**Re: An Bord Pleanála Reference PA0033; Applicant; Galway Harbour Company – Galway Harbour Extension – Direct Application to An Bord Pleanála in respect of a Strategic Infrastructure Development**

We refer to the above application and wish to advise that on behalf of Bus Éireann, we would like to make the following observations;

**Existing Ianród Éireann rail freight depot and access gate on to the Lough Atalia Road (Lough Atalia Bridge in background)**

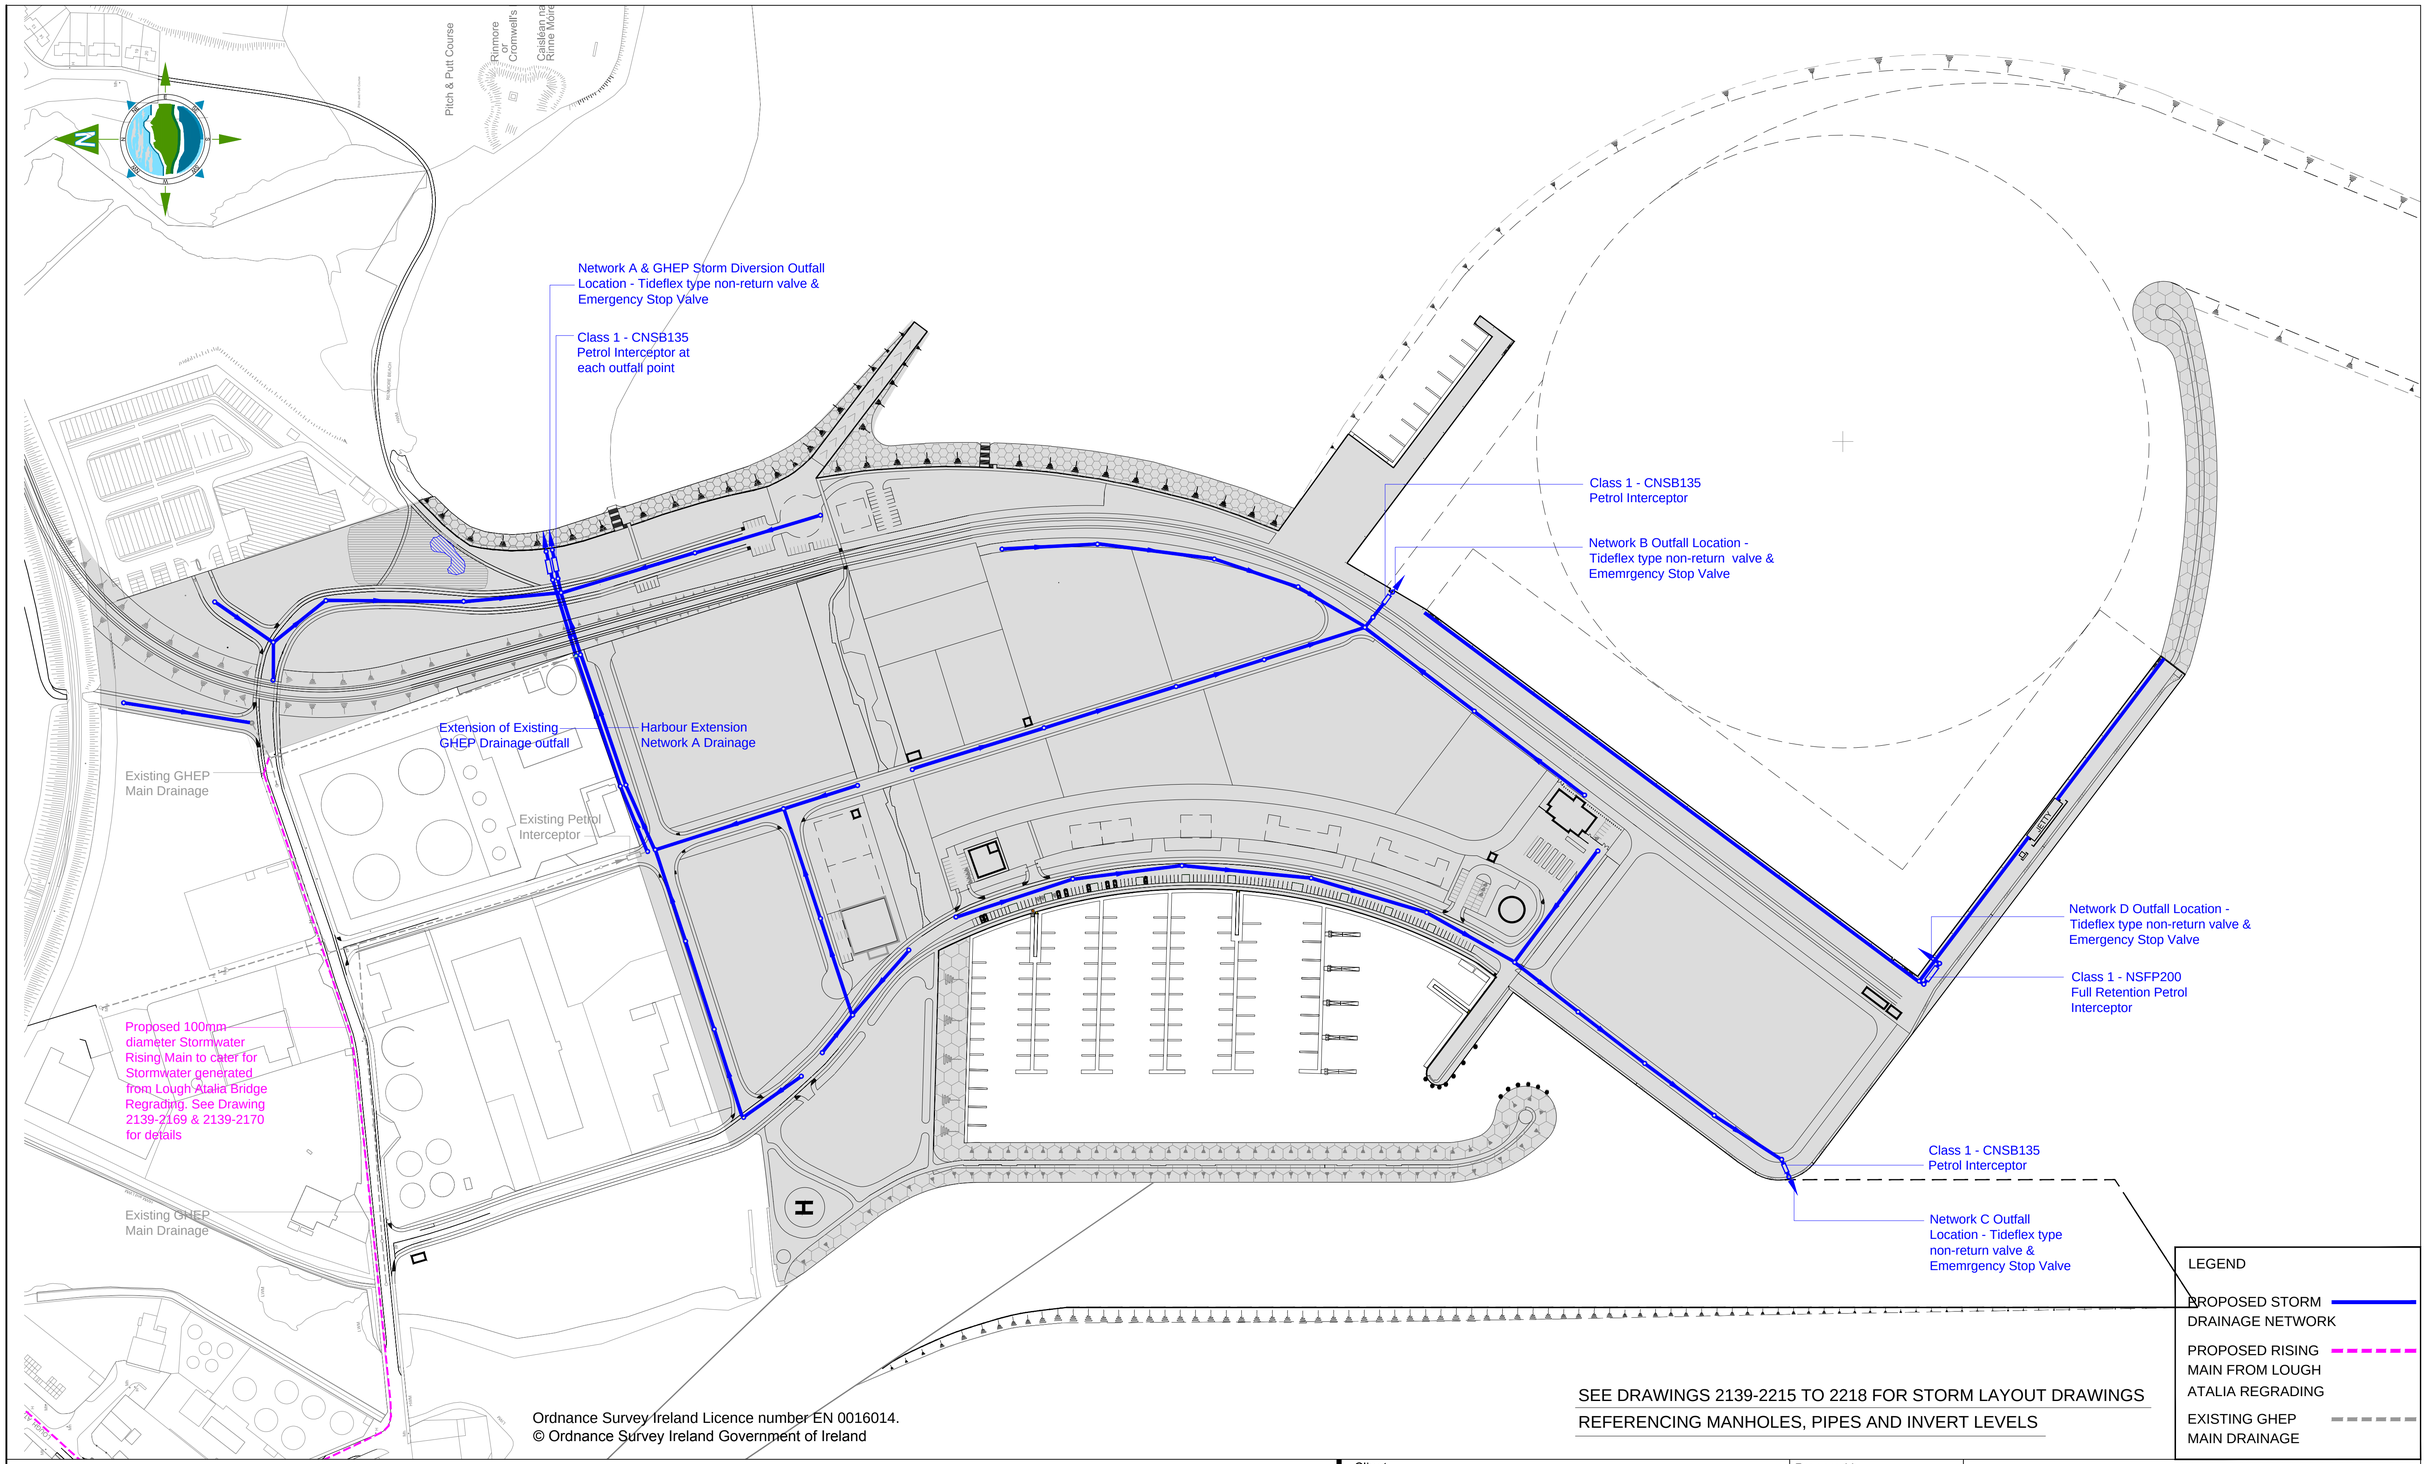
4. It may be beneficial to improve the rear access road into Ianród Éireann's rail freight yard, accessed via the Lough Atalia Road approximately 150m South West of the Lough Atalia Bridge for bus access and storage, see appendix A, this is presently be used for buses to access and park overnight in the freight yard, this could be developed to allow Bus Éireann buses drive through the

car park to the rear of Céannt Train Station and onto Eyre Square south. If this access route was used for the duration of the construction phase it would relieve traffic pressure during the docks road and rail spur construction. This will obviate the necessity for Bus Éireann buses to undertake the proposed diversions during the construction phase as outlined in drawing no. 2139-2179 A, see appendix A for photograph of freight access. This would significantly reduce the impact on Bus Éireann public service timetables. We would request that the traffic management plans reflect and incorporate our proposals to allow access though this freight yard and access onto Eyre Square south.
